PARK PLACE AT WESTCHESTER AIRPORT

Draft Supplemental Environmental Impact Statement

DRAFT SUPPLEMENTAL ENVIRONMENTAL IMPACT STATEMENT

March 22, 2016

EXCAVATED CONCRETE WASHOUT STATION
N.T.S.

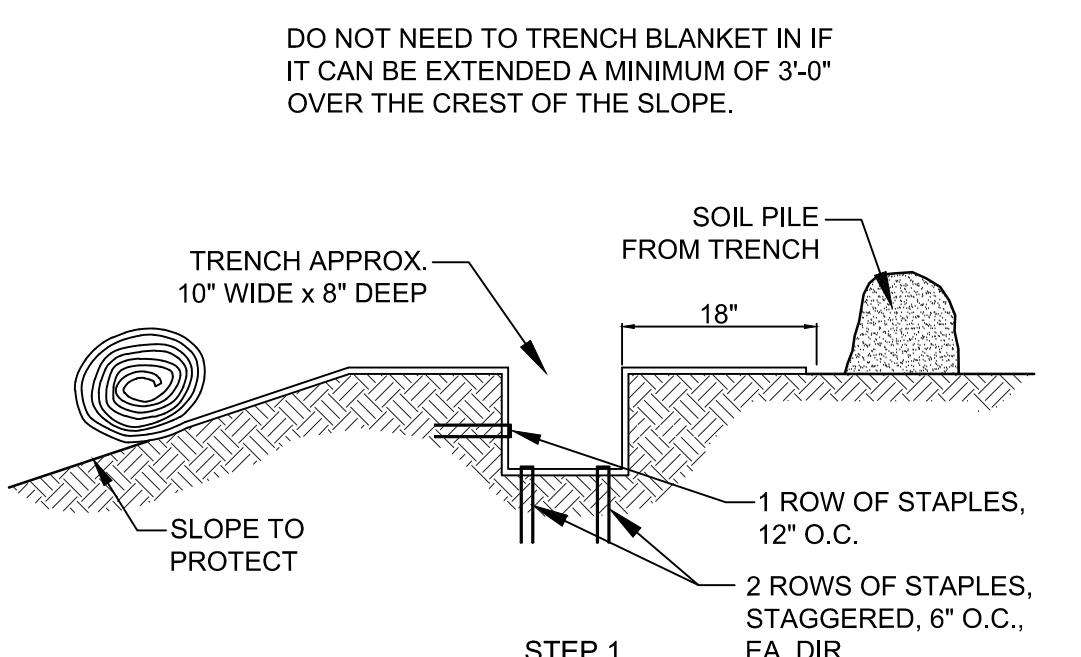
Comment 23: A concrete truck washout facility must be added to the SWPPP in Sections 7.1, Erosion and Sediment Control Practices, and 8.1, Inspections and Record Keeping During Construction. It should also be included on the drawing C-1, Notes and drawings C-8, Erosion and Sediment Control Plan and C-13, Standard Details IC. Although a concrete truck washout facility is acknowledged in the "Comments and Responses" on page 3-249 of Chapter 3 in the FEIS, it must be placed on the applicable drawings and incorporated more fully into the SWPPP. (Office of the Watershed Inspector General, 2/19/15)

A concrete truck washout facility must be added to the SWPPP in Sections 7.1, Erosion and Sediment Control Practices, and 8.1, Inspections and Record Keeping During Construction. It should also be included on the drawing C-1, Notes and drawings C-8, Erosion and Sediment Control Plan and C-13, Standard Details IV. Although a concrete truck washout facility is acknowledged in the "Comments and Responses" on page 3-249 of Chapter 3 in the FEIS, it must be placed on the applicable drawings and incorporated more fully into the SWPPP.

Response: A concrete washout area has been added to the site details, see Drawing C-10.

TURFSTONE DETAIL
N.T.S.

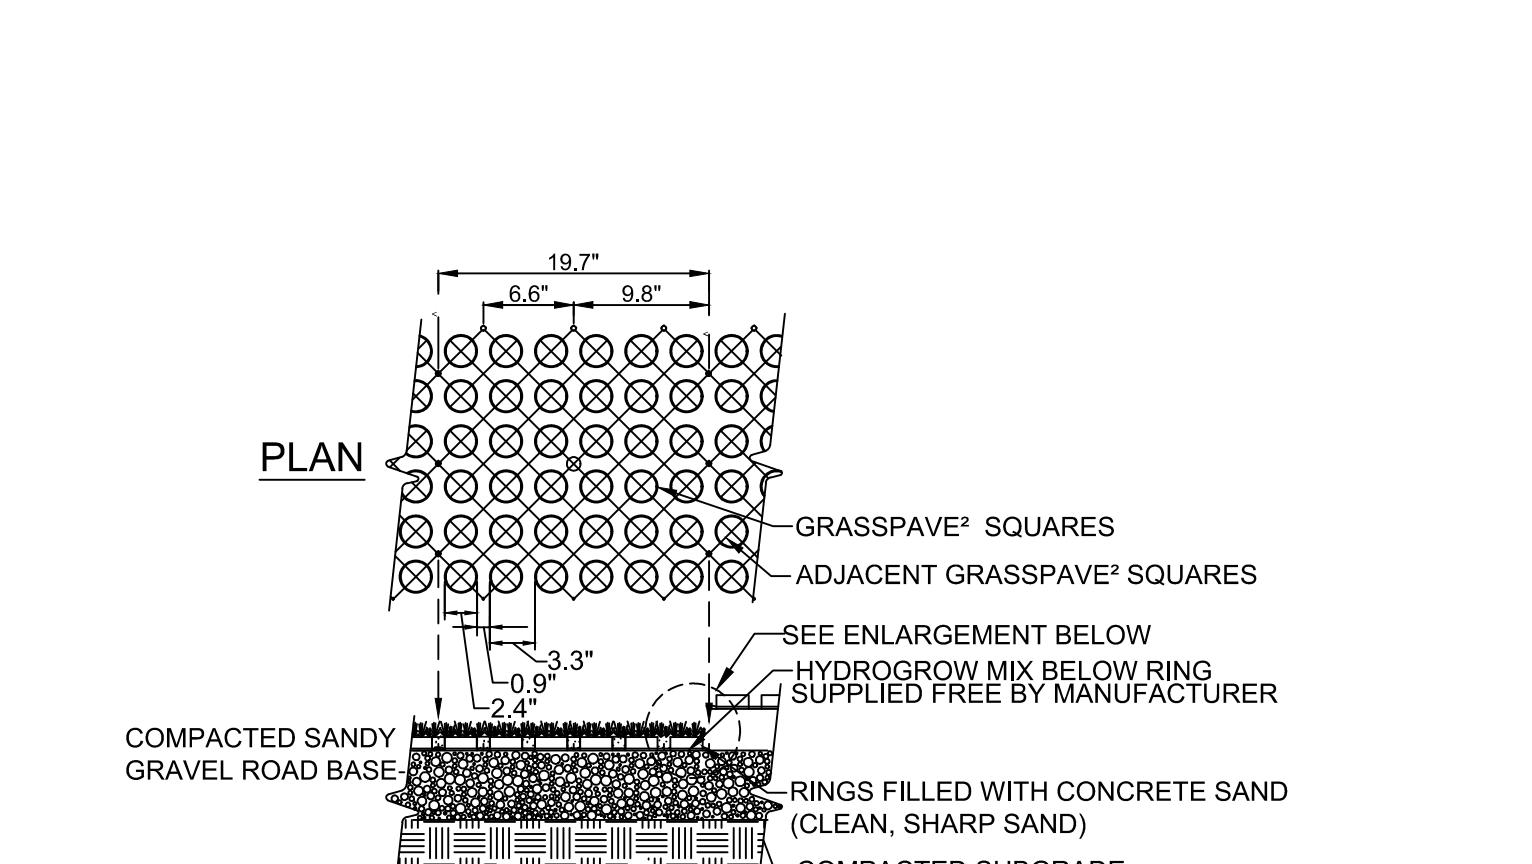
31. "Turfstone" permeable paver units are described in the SWPPP on page 15 and are shown in detail on Sheets C-5 and C-11. The detail on Sheet C-11 shows the permeable paver incorrectly depicted on a slope instead of on level ground to the south side of the facility. As such, this detail is incorrectly labeled. In addition, the depth dimensions associated with determining the amount of water that can be stored beneath the permeable pavers is missing. Finally an underdrain should also be provided in low permeable soil, such as the Ridgebury loam on site.
